Response to Additional Information Request: Integrated Designated Development Application No. 523/2014. Dunmore Resource Recovery Facility Redevelopment – Buckleys Road, Dunmore

This letter provides a response to additional information requests provided by Shellharbour City Council (SCC) – City Projects, dated 17th February 2015 and the NSW Environment Protection Authority (EPA) data 25th February 2015.

Table 1: Response to comments raised during the public exhibition period

Drawing No.	Project No.	Issue
SK0006	AA005925	P1

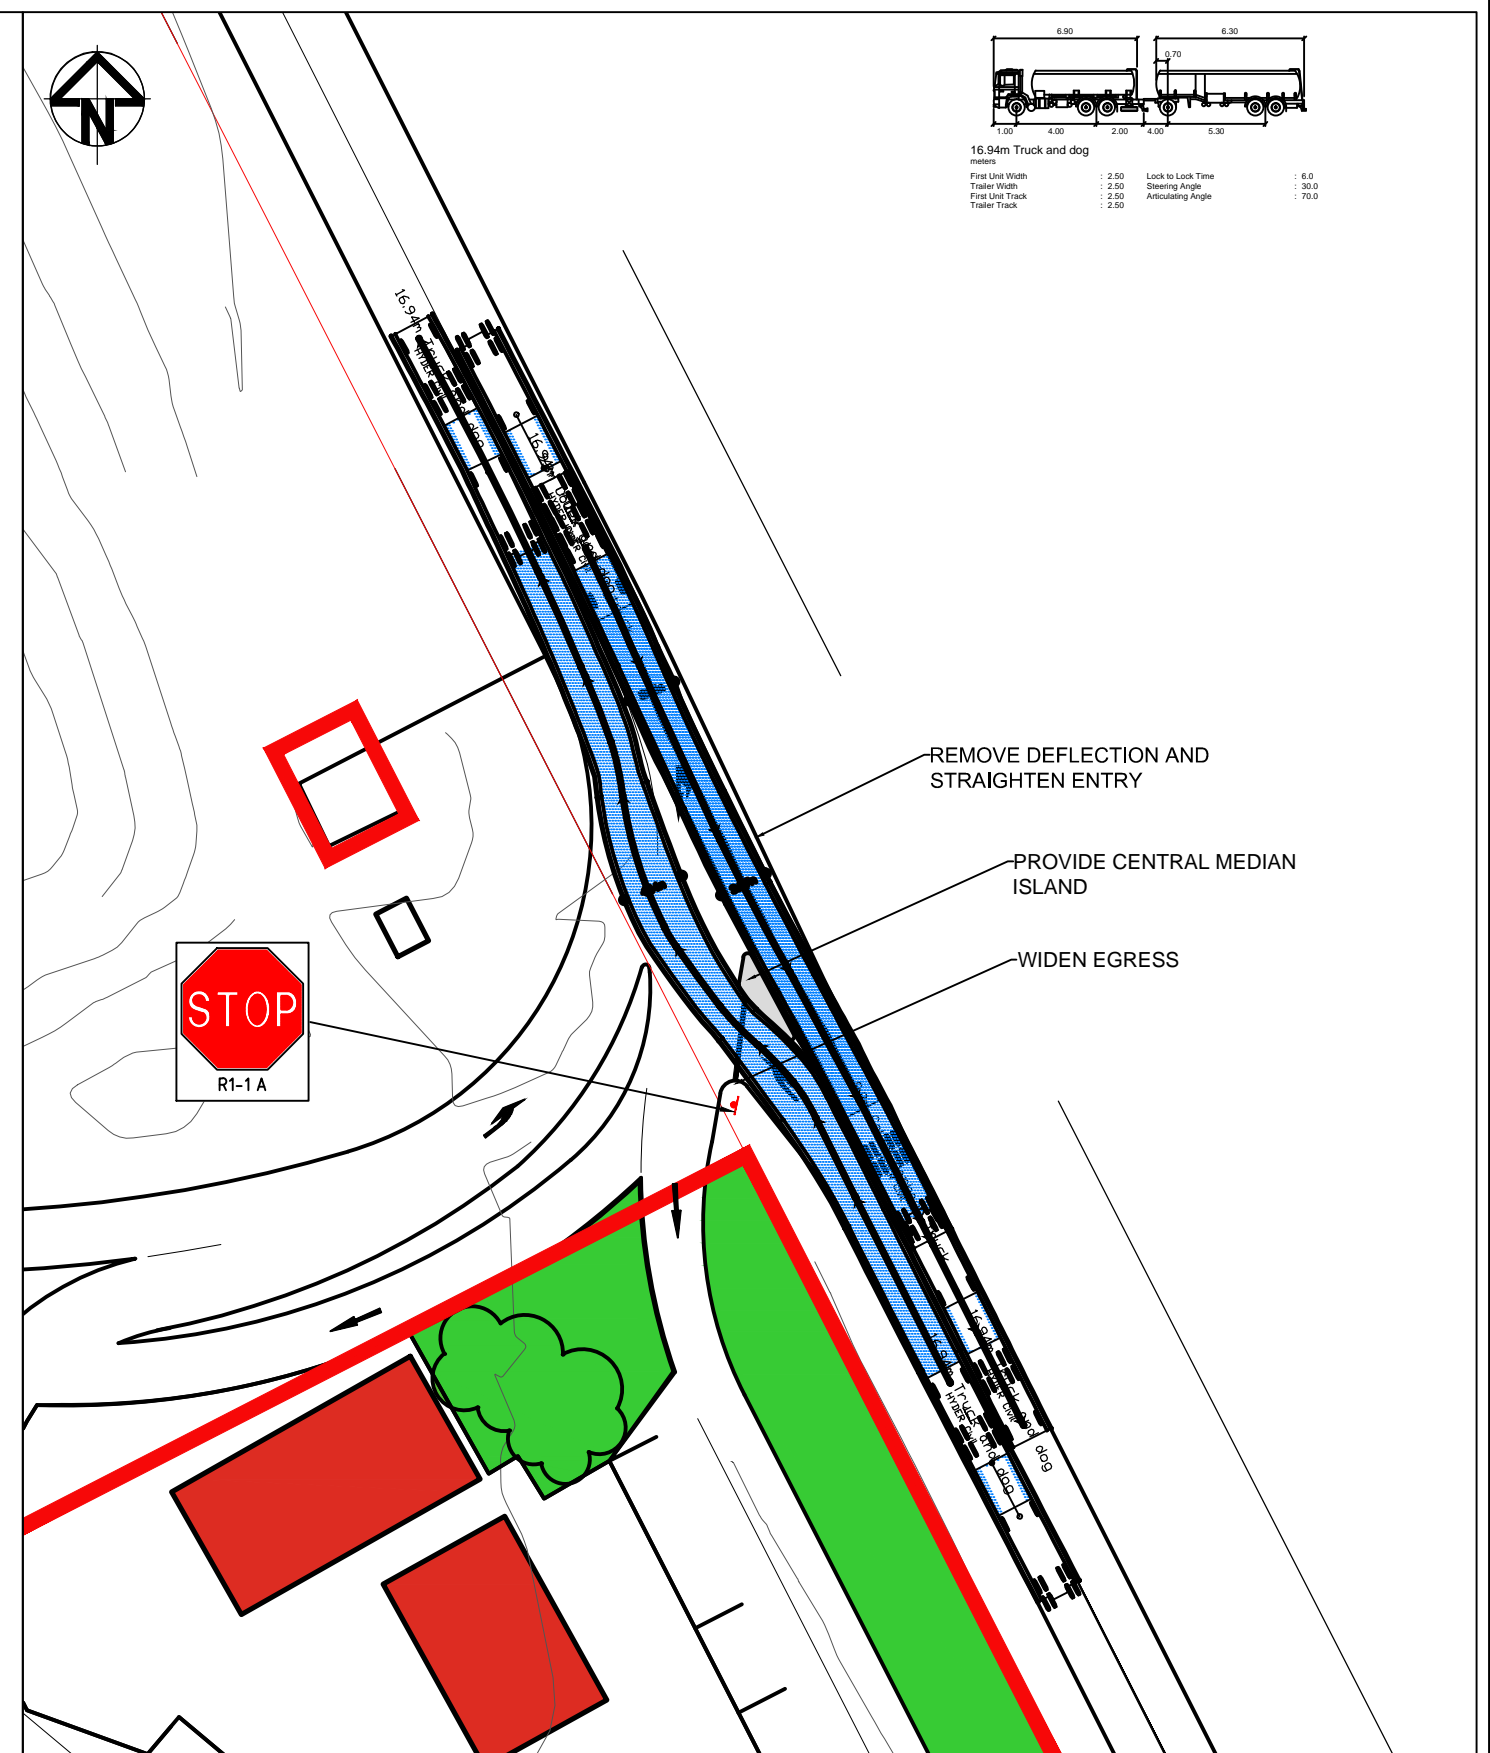
Issue	Comment	Clarification / Response	Reference
	<p><i>"They are concerned that vehicles wishing to enter their property will have to first negotiate the proposed blister in the road alignment. Our client's operation attract heavy vehicles including trucks with "dogs". They are concerned that the re-configuration of the road alignment intended under this proposal will result in trucks wishing to enter their site leaving the left hand side of the road to negotiate these changes to the road alignment and then crossing onto the right hand (i.e. wrong) side of the road leading to traffic safety concerns and conflicts with on-coming vehicle leaving their site.</i></p> <p><i>Furthermore, heavy vehicles leaving our clients property will also be required to stop at the proposed entrance to the subject site to allow vehicles entering the subject site to pass. Apart from the nuisance for a possibly heavy laden heavy vehicle to have to negotiate a stop on an incline, such a traffic manoeuvre seems to be contrary to normal traffic movements where traffic traveling along a public road has to give way to traffic entering a "private" property. Such circumstances may also raise traffic safety issues with driver uncertainty at such an intersection.</i></p>	<p>immediate action with too little distance/time to comprehend and act. To rectify this issue the entry sequence must be a logical, free-flowing series of intuitive events that puts the patron at the desired destination with minimal wayfinding signage and decision making actions.</p> <p>The proposed layout of the resource recovery facilities has been arranged to separate the heavy vehicle (commercial) from the light vehicle (retail) traffic while minimising the number of potential points of conflict (two potential points of conflict as opposed to seven points of conflict under the existing layout).</p> <p>It is acknowledged that the proposed reconfiguration would re-direct traffic from a public road into the facility. The Proposal will operate as a public facility for use by the surrounding community. Given the nature of the Facility, and the high proportion of the traffic travelling on Buckleys Road that are associated with the Proposal, a reconfiguration is considered appropriate to maximise safety and traffic flows on Buckleys Road and within the site.</p> <p>The DRWDD site is accessed by approximately 162 light vehicles and 74 heavy vehicles per day - a total of 236 trips (472 movements). In comparison the neighbouring DRR site generates approximately 13 heavy vehicle trips (26 movements) per day. As over 94% of traffic accessing the southern portion of Buckleys Road are associated with the DRWDD site, the reconfiguration of the entrance was determined to provide the greatest safety and traffic flow outcome.</p> <p>Notwithstanding the above comments, to address safety concerns and issues identified by for the DRR site, alternate configurations for the site access have been developed. The Hyder traffic team, as part of this response identified three options for the reconfiguration of the site access, and the advantages and disadvantages associated with each options were considered in collaboration with SCC. The preferred proposed site access layout is provided in Appendix A of this letter.</p>

Issue	Comment	Clarification / Response	Reference
	<p>.....</p> <p><i>Such a re-configuration of a public road to re-direct traffic from a public road into a "private" property is inconsistent with normal traffic engineering practice. Normally in circumstances such as this, a developer would be required to upgrade the public road intersection to ensure the flow of traffic along the public road was not interfered with, by requiring the channelization of right turn movements into the site within a separate designated right hand turn lane, while retaining a specific lane for traffic movements along the public road to be left uninterrupted."</i></p>	<p>The reconfigured site access will allow vehicles accessing the DRR site to continue unimpeded along Buckleys Road from the north-west. Vehicles heading north and south will be separated by a traffic island, which will act as a traffic control measure on vehicles exiting the private facility, and encourage drivers to reduce speed on approach to the intersection. This will reduce the risk of head on collisions and provide separation to vehicles entering and leaving the DRR site at the location of the intersection.</p> <p>Vehicles travelling on the main road would still have priority over vehicle egressing from the DRR site. Adequate lines of sight are available for vehicles exiting this facility. The swept paths of both entry and exit vehicles are unhindered and both movements can operate simultaneously.</p>

Concept Stormwater Management Plan

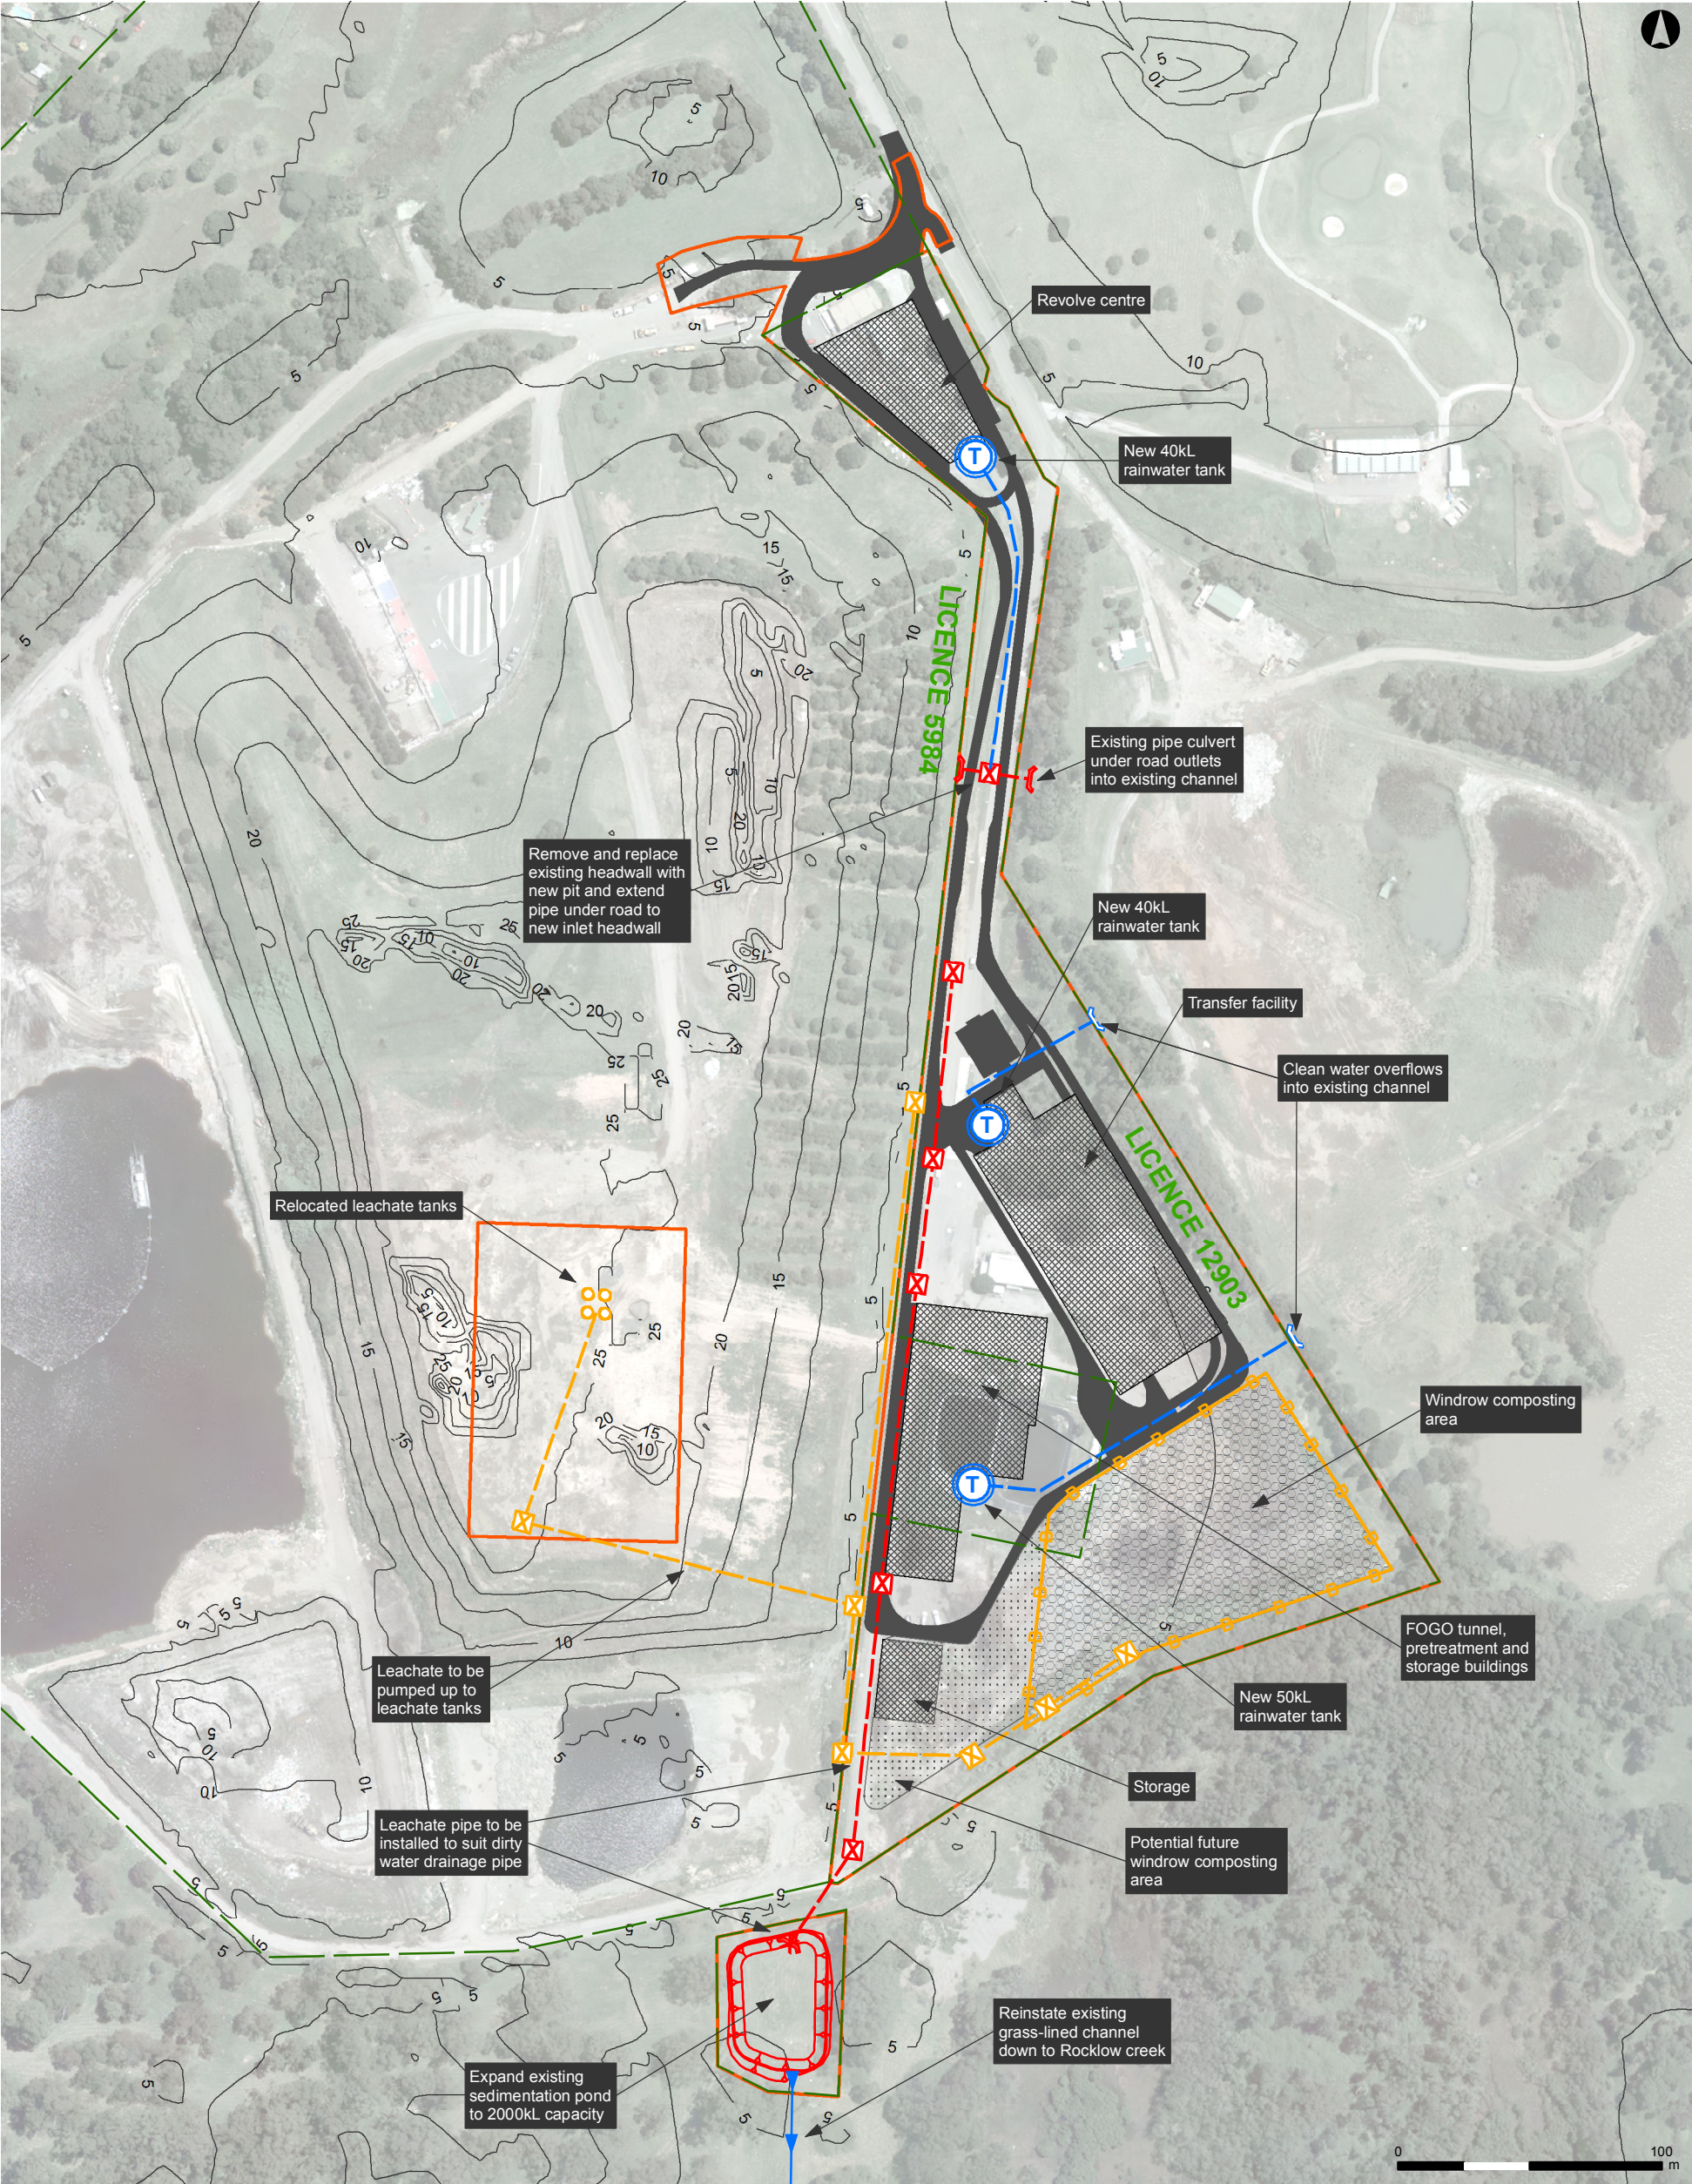
Issue	Comment	Clarification / Response	Reference
	<p>the subject site and retaining the alleged drainage channel on the DRR and retaining the discharge of stormwater into the water storage pond located on the DRR site.</p> <p>Our clients advise that whilst there is a drainage channel that runs along the eastern boundary of the subject site shared with their land, this drainage channel is not located on their land as shown on these figures but is located on the subject site. Furthermore this drainage channel does not drain into the water storage pond that is located on the DRR land. Rather this drainage channel discharges stormwater flow from the subject site directly into Rocklow Creek further to the south."</p> <p>Method of stormwater disposal for Revolve Centre</p>	<p>sub-catchment (also referred to as sub-catchment No. 6). The runoff from this area of the Proposal site is transported into the existing drainage channel via an existing culvert which flows into an existing dam on the DRR site.</p> <p>This subcatchment includes a 400m long section of Buckleys Road and thoroughfares serving the depot buildings. These road surfaces, which represent approximately 25% of the subcatchment area, currently generate pollutants and pollutant loads typical of heavy vehicle traffic.</p> <p>The proposed works within subcatchment no. 6 (principally the northern part of the Proposal site associated with the Revolve Centre works) include: 1) modification of the existing roads to improve traffic movements within the site; 2) removal of existing buildings and construction of an awning over the Revolve Centre building. These works are not expected to significantly change the quantity and quality of runoff leaving the proposed site from the existing current conditions. The design intent of the stormwater concept plan in this area was to maintain the existing flow regime. This is achieved by extending the existing culvert to suit the proposed roadworks.</p> <p>All runoff generated within the southern half of the Proposal site, comprising the Organics Facility and Transfer Station areas of the development, will be drained internally and conveyed via a pit-and-pipe system to an existing sedimentat pond located to the south, is expanded to accommodate the increased volume of runoff.</p> <p>When the capacity of the pond is exceeded, overflows are conveyed by a new drainage channel that discharges into Rocklow Creek in accordance with EPL requirements. The design intent of the concept stormwater plan in this area is that will be no discharge from the southern section of the proposed site into the adjoining property.</p> <p>The stormwater concept plan provided in Volume 2 of the EIS – Appendix J has been updated to ensure this is clearly presented (refer Appendix B of this Letter).</p>

Issue	Comment	Clarification / Response	Reference
		<p><u>Stormwater Disposal – Revolve Centre</u></p> <p>As mentioned above, runoff from the Revolve Centre sub-catchment is collected by existing drainage channels. An existing culvert underneath the perimeter road conveys stormwater flows to the existing downstream drainage channel, located along the eastern boundary of the Proposal site and the existing dam within Lot 2 Buckley Road. This catchment and its attendant drainage system will be maintained as part of the Proposal, except to modify and extend the existing culvert to suit new roadworks.</p> <p>A clean water roof drainage system for the Revolve Centre was omitted from Volume 2 of the EIS – Appendix J: Stormwater Concept Plan. This has been updated to incorporate a 40KL tank adjacent to the Revolve Centre. This will assist in promoting water re-use and reducing overall operational water demands for the site as well as reducing stormwater runoff. This is reflected in the updated stormwater concept plan provided in Appendix B.</p>
